RE: M-Keds Plat 1 Lot 2 Site Plan

The Development Services Department is in receipt of a proposed Site Plan for M-Keds Plat 1 Lot 2. Based on the review of the provided submittal materials, staff have the following comments:

- Architectural elements
1. Varying roof height
 2. Awning
 3. Vertical Element
 4. Banding
 5. Varying materials

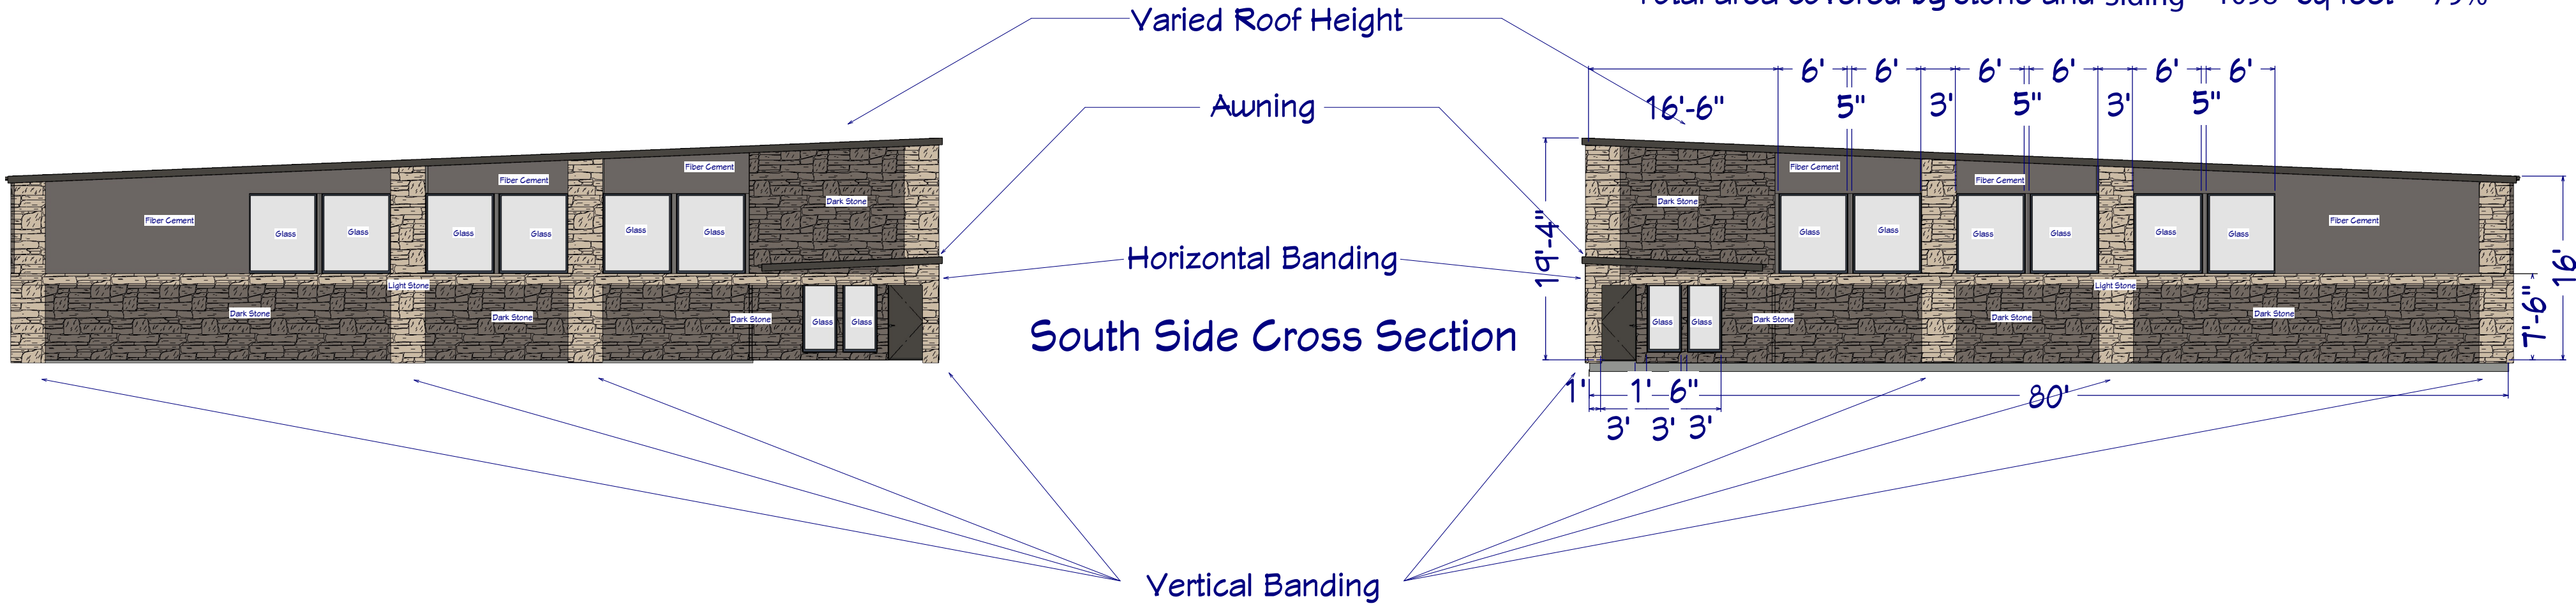
1. ~~Five architecture elements are required per the Highway 141 Corridor design standards. It appears there are only two (awning and variation in roof height). Please add the 5 elements to the elevation plan.~~
2. ~~The east and north wall is blank. No blank wall area or façade shall exceed 30 feet in horizontal or vertical direction.~~
3. ~~Elevation is only shown for one of the buildings. Provide the elevation of the other building. Still needed.~~
4. ~~Up lighting is required on the south elevation. Still needed.~~
5. ~~The calculation for the stone area does not meet the 75% minimum (823 sf is required).~~
6. ~~On the east elevation, show 10' of stone extending from the front building face.~~

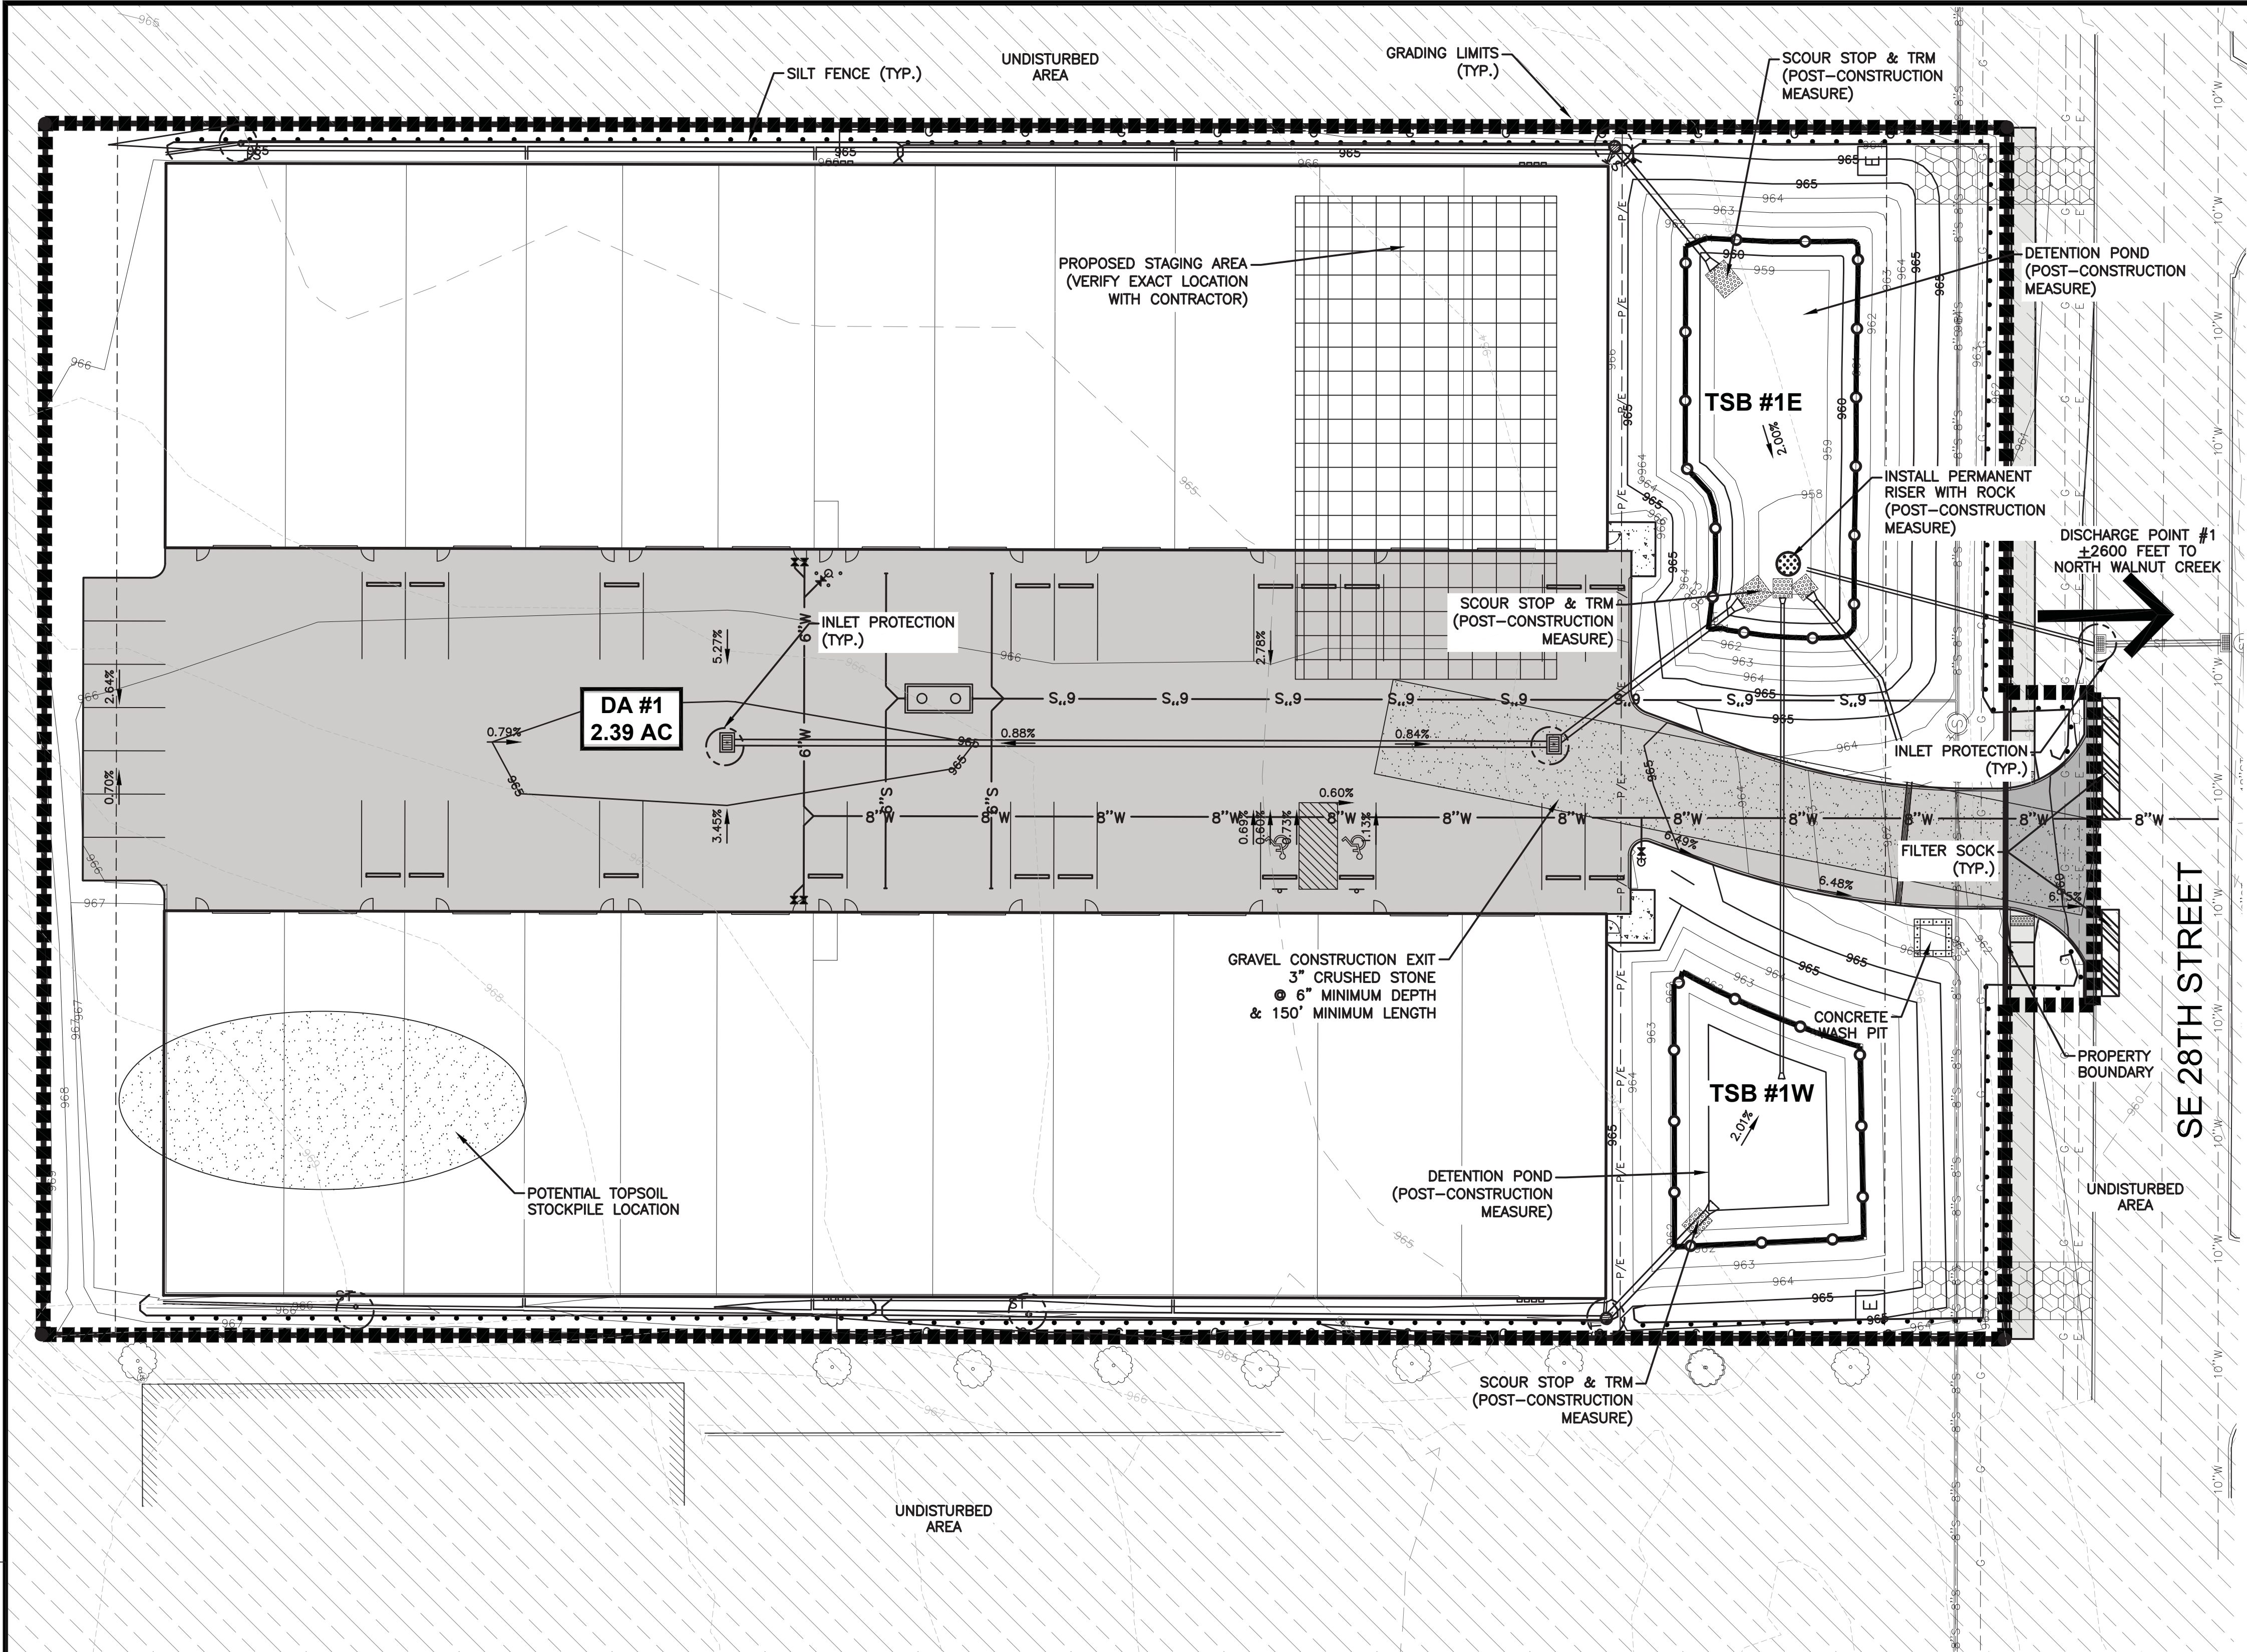
- ~~1. NPDES note above title block calls for grading permit from City of Grimes.~~
- ~~2. Update the construction schedule to reflect the site plan approval schedule.~~
- ~~3. Update the open space calculation. 15% open space is required.~~
- ~~4. What is the phasing plan? Will you be building both buildings now?~~

UTILITY PLAN

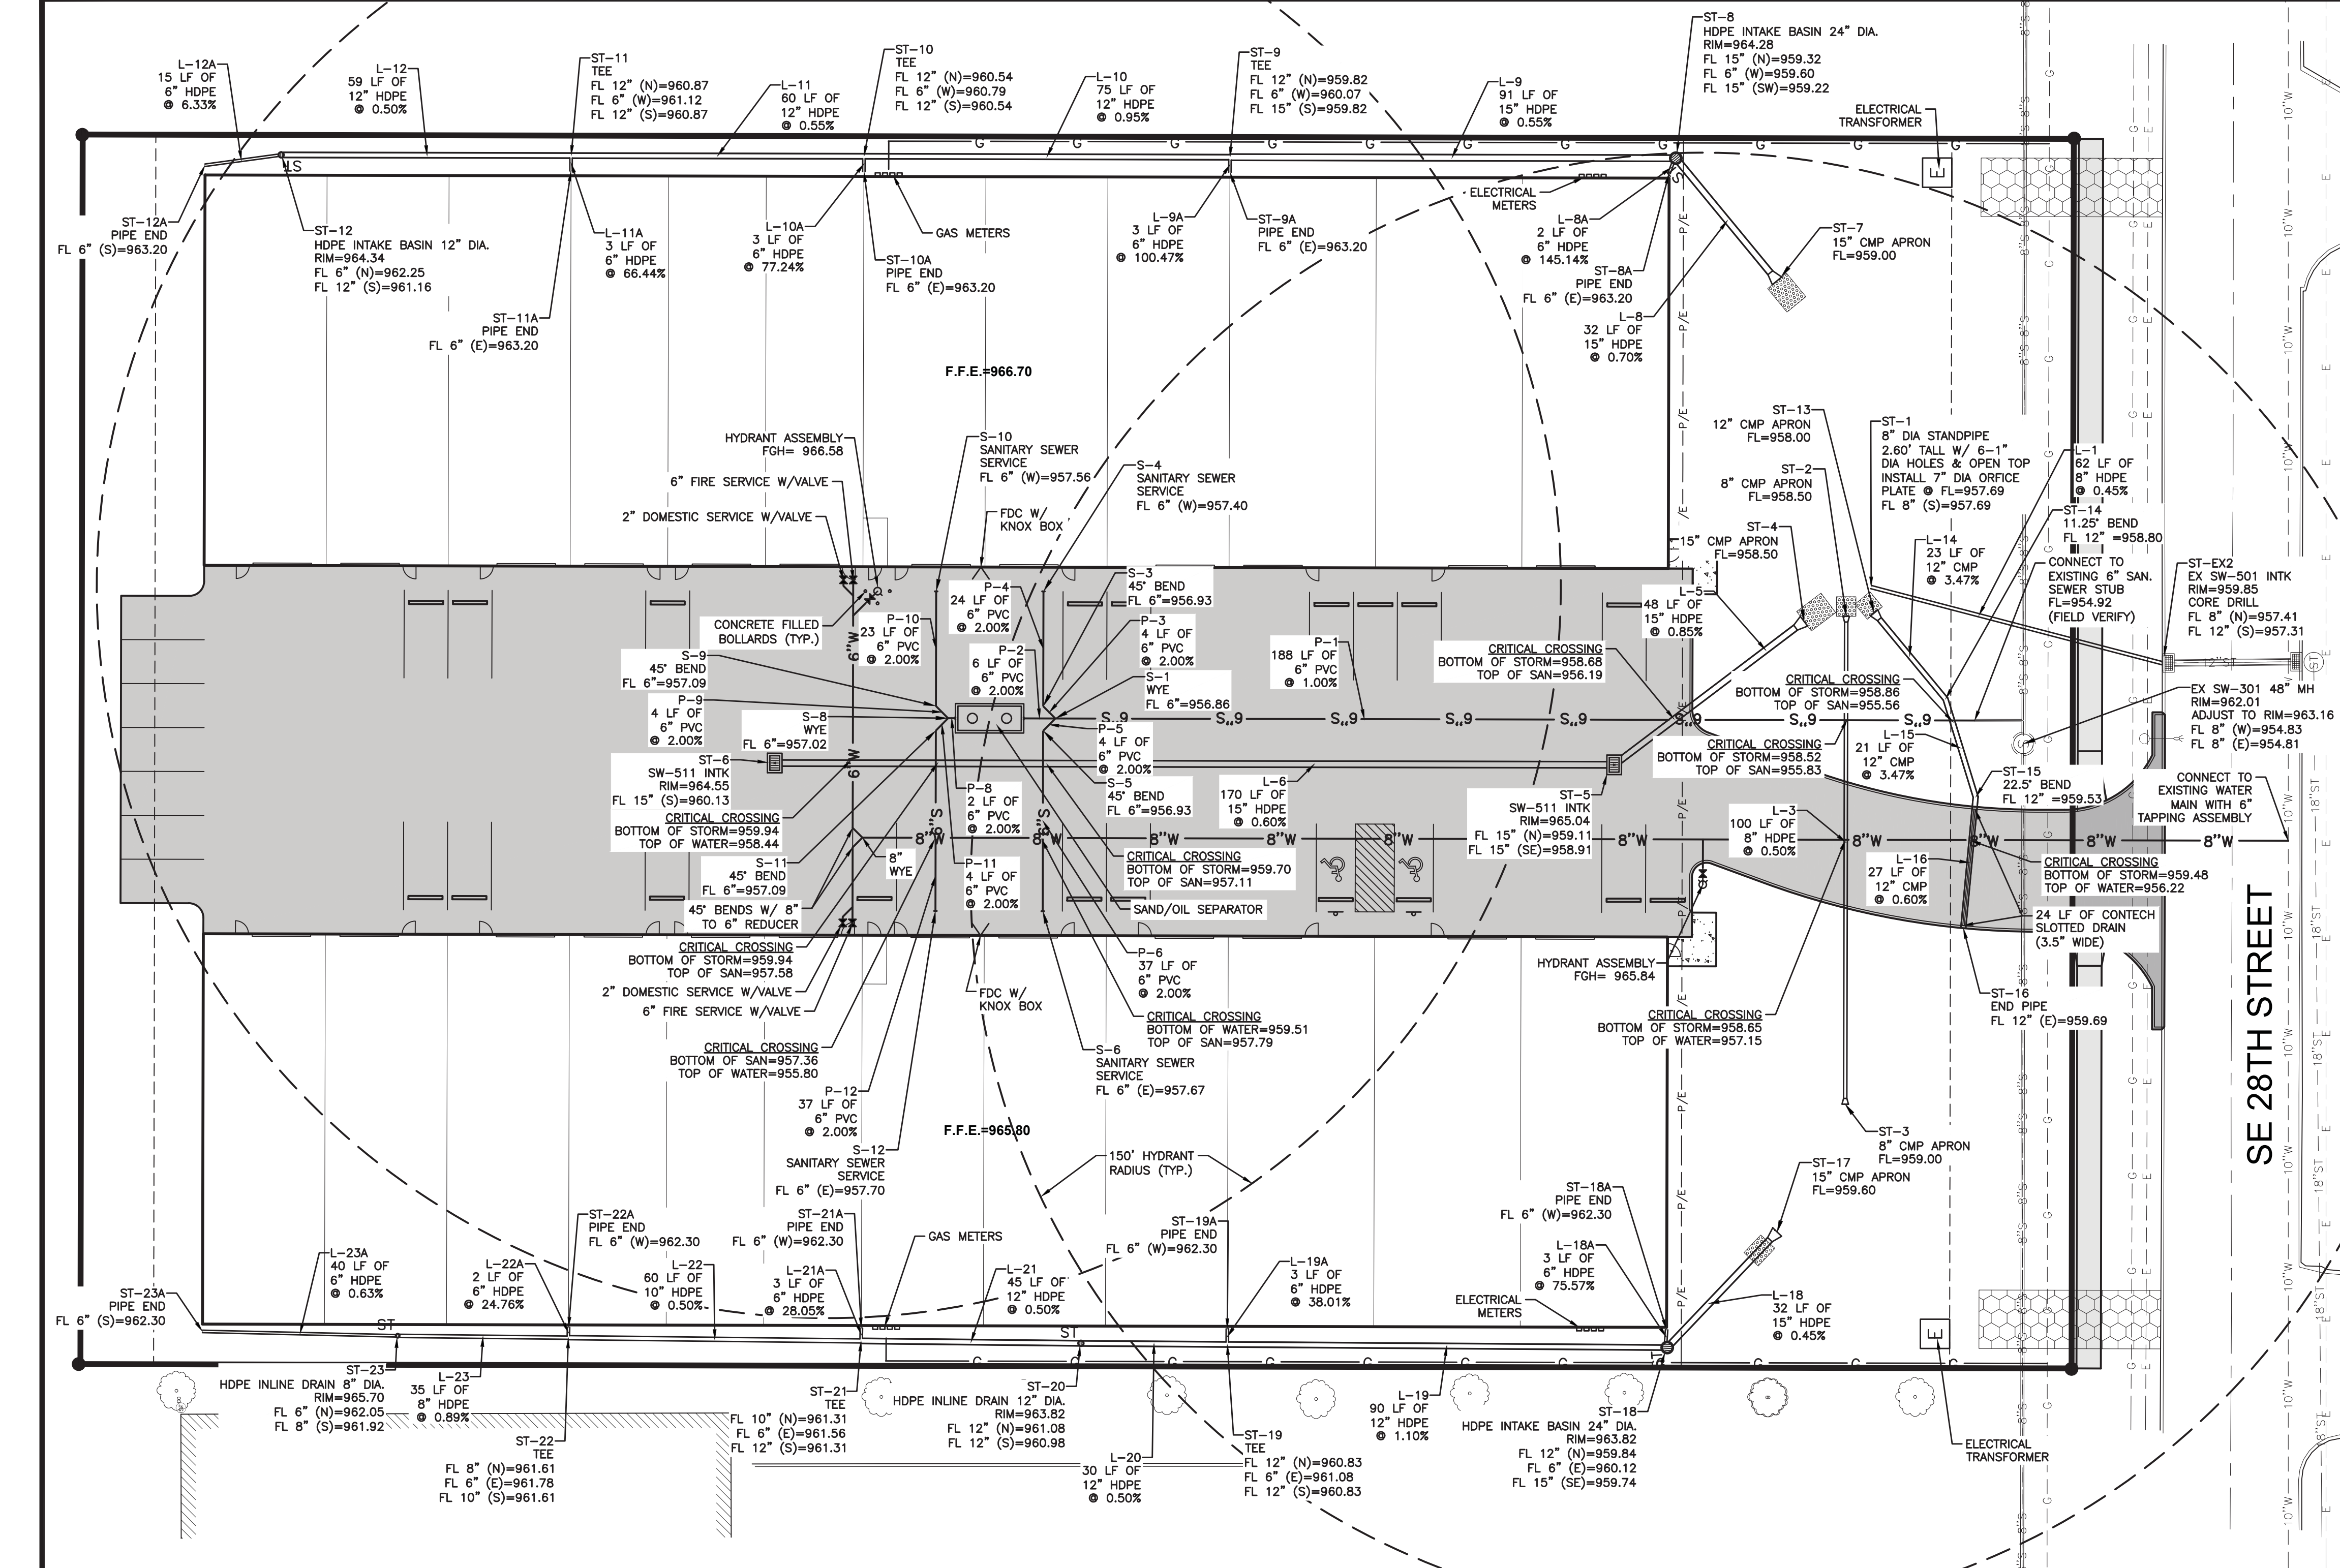
- ~~1. Verify if there is an existing sanitary service stub at connection to sanitary.~~
- ~~2. Sanitary services to be 6" diameter.~~
- ~~3. Separate domestic and fire services outside of building and provide a valve/curb stop on each.~~
- ~~4. Why is there a sand/oil separator located in the middle of the parking lot? Please provide details on the use/occupancy that would require a sand/oil separator.~~
- ~~5. Show roof drain connections.~~
- ~~6. The manhole along SE 28th Street may need to be adjusted due to proposed grading.~~
